From: [REDACTED]@southwark.gov.uk>
Sent: 04 January 2023 12:47
To: [REDACTED]@tfl.gov.uk>; [REDACTED]
[REDACTED]
Cc: David Oram [REDACTED]@tfl.gov.uk>; Wilfred Macfoy [REDACTED]@tfl.gov.uk>;
Jagvir Dosanjh [REDACTED]@tfl.gov.uk>
Subject: RE: 08/023 Proposed MOC

Below is the amended MOC. It aligns with what LB of Southwark require.

From: Dosanjh Jagvir [redacted] <[redacted]@tfl.gov.uk>
Sent: 04 November 2022 10:41
To: Macfoy Wilfred (ST) [redacted] <[redacted]@tfl.gov.uk>; Oram David (ST) [redacted] <[redacted]@tfl.gov.uk>
Subject: 08/023 Proposed MOC

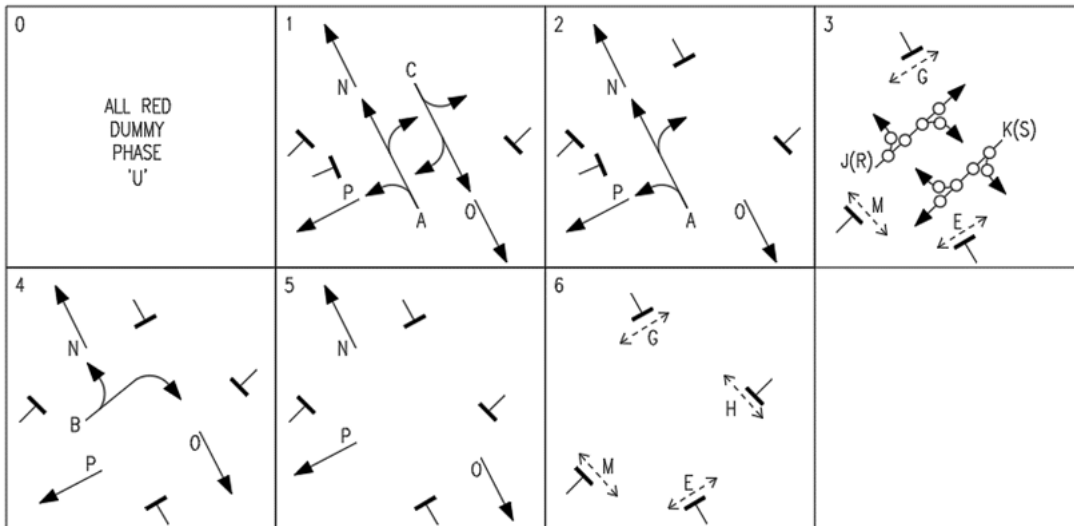
NPD (David) has spotted an opportunity to optimised the proposed cycle time at this junction by moving the pedestrian phase 'H' from stage 6 in to stage 4. By doing that, we do away with the proposed all round pedestrian stage 6, as all the pedestrian phases will be called as walk with traffic phases.

Can we have you opinion on this please?

Yes you are correct Wilfred. There is a concern that cyclists using the general traffic lane on Turney Road will ignore the traffic signs and go ahead onto Calton Avenue, so lets not run the ped phase at the same time to remove this potential conflict.

It is fine for there to be no intergreen between the two phases. But we would still not want them running in the same stage due to the amount of cyclists and issues that exist at the site.

Just discussed the conflict with phase B & H. Firstly, the original timing sheet I created which has no intergreen between phases B & H or H & B, has been through a safety audit and has passed. A possible conflict between phases B-H was not flagged. Secondly, I've just asked an independent engineer and he agrees that there should be no intergreen between phase B & H. Phase B permits vehicles (cars) to turn left or right. If this was a full green however, then that would mean there should be an intergreen between these two phases.

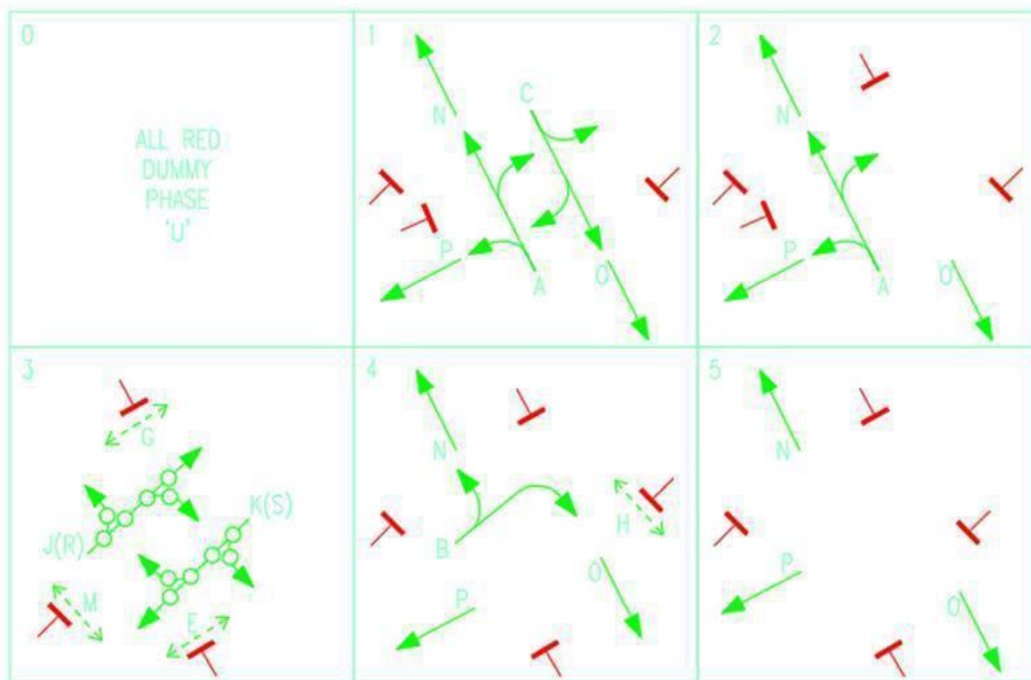
Further to our conversation NPD would like to amend the MOC. Currently this is what has been proposed with an all-round ped stage:

NPD have proposed to remove the all-round ped stage and have phase H running in stage 4 as there are no conflicts. It is only cyclists (phases J, K, R & S) who can pass through phase H. The MOC will look as below:
